# UNITED STATES PATENT AND TRADEMARK OFFICE

APPLICATION NO.	FILING DATE	FIRST NAMED INVENTOR	ATTORNEY DOCKET NO.	CONFIRMATION NO.
10/814,156	04/01/2004	Keith L. Knisley	22349.00	7368
37833	7590	03/13/2006	EXAMINER	
LITMAN LAW OFFICES, LTD PO BOX 15035 CRYSTAL CITY STATION ARLINGTON, VA 22215			MICHALSKI, SEAN M	
			ART UNIT	PAPER NUMBER
			3725

**Office Action Summary**

## **DETAILED ACTION**

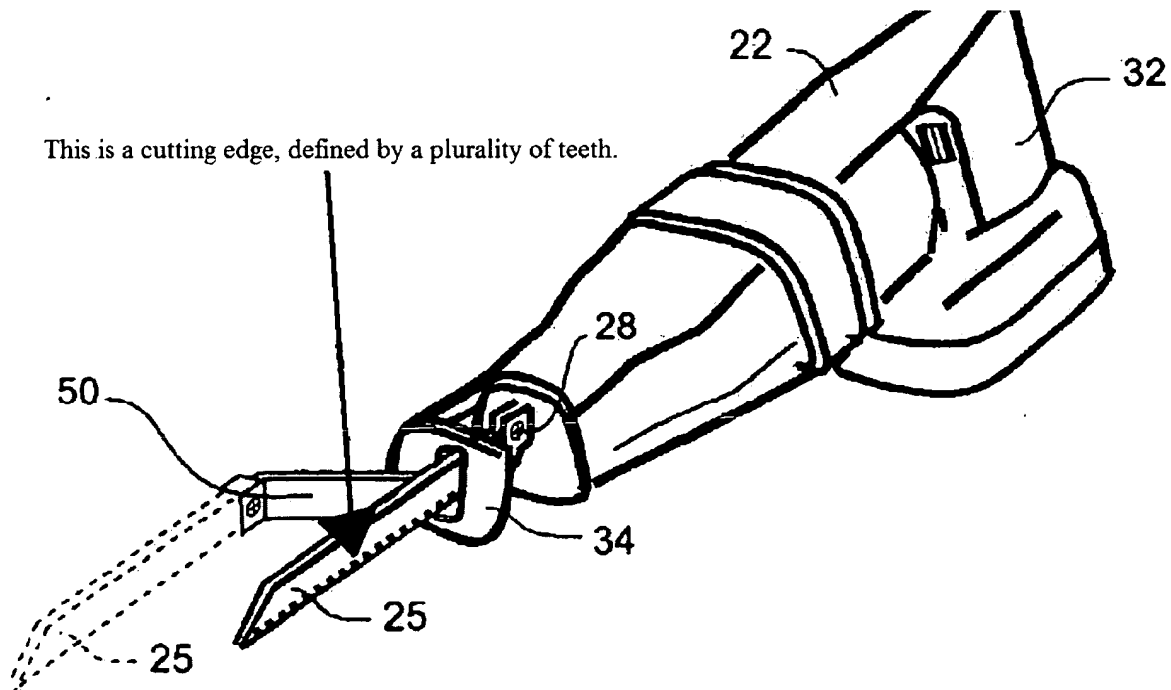
Reale discloses a saw blade (50 figure 1) with a flat elongated mounting arm (62 figure 2) having a saw mounting end (the portion of 62 by 28 figure 2) adapted for attachment to a reciprocating saw (seen in figures 1 and 2) and having a second end (the end of 62 not connected to 28, figure 2). Reale further discloses a flat elongated connector arm (64 figure 2) with a first end attached to the second end of the mounting arm (seen in figure 2). Reale further discloses a flat elongated cutting blade having a first end (66 figure 2) connected to the second end of said connector arm (the end of 64 which connects to 66) and a second end (25 figure 2). The cutting blade further comprises a first cutting edge (see picture below) having a plurality of teeth (again refer to picture below).

Reale further discloses that said cutting blade and mounting arm are parallel (they are shown to be parallel in figure 2). Reale further discloses that the cutting blade

can be placed flush against one surface of a 90 degree corner in order to cut around the corner (making a flush cut is described column 3 lines 35-50), the cutting arm being offset from the mounting arm by a distance substantially equal to the length of the connector arm (the distance D in figure 2 is substantially equal to the length of 64).

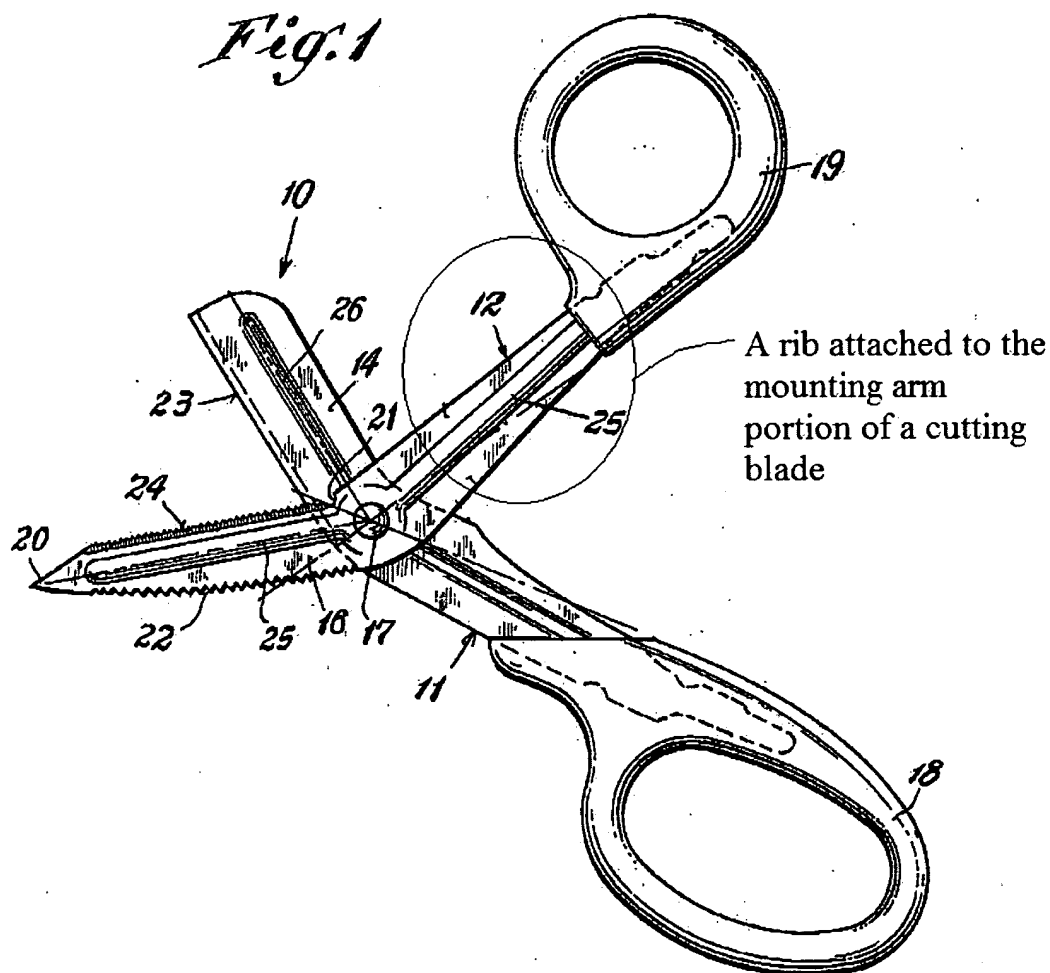
Visco teaches the use of a reinforcing rib (25 and 26 figure 1, as indicated below)

located on the mounting arm section of a cutting blade for the purpose of adding

strength (column 2, lines 44-45). In the same problem solving area it would have been obvious to one skilled in the art at the time of the invention to modify Reale et al. in view of Sweeney et al. by providing the cutting blade with a reinforcing rib as taught by Visco. The motivation to combine is that the rib would provide additional strength. Adding a rib for the stated motivation of providing additional strength requires only routine skill in the art.
